CITY OF ALBUQUERQUE

RE: Lot 30 Block 6 Unit 18 SAD 228 6539 Pato Dr. NW Volcano Cliffs Subdivision Grading and Drainage Plan Engineers Stamp Date 12/7/2021 (D10D003M30)

LOT 30 BLK 6 UN 18 VC 6539 PATO DRIVE GRADING AND DRAINAGE PLAN

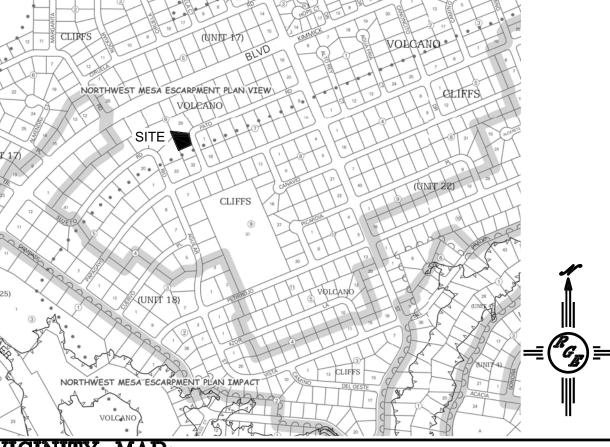
Based upon the information provided in your submittal received 8/30/2021, this plan is approved for Grading Permit.

Prior to Building permit approval a Pad Certification will be required, provided by the Engineer or a registered Land Surveyor.

Advise the owner contractor not to use dirt as a ramp to climb the curb, use lumber or crusher fines for this purpose.

Reiterate to the Owner/Contractor that a separate permit for a garden/retaining wall must be obtained with the approved G&D plan and Pad Certification. Also, if a swimming pool is to be placed after this approval a new grading and drainage plan will need to be resubmitted showing the changes for the land treatments.

Prior to Certificate of Occupancy release, Engineer Certification per the DPM checklist is required.
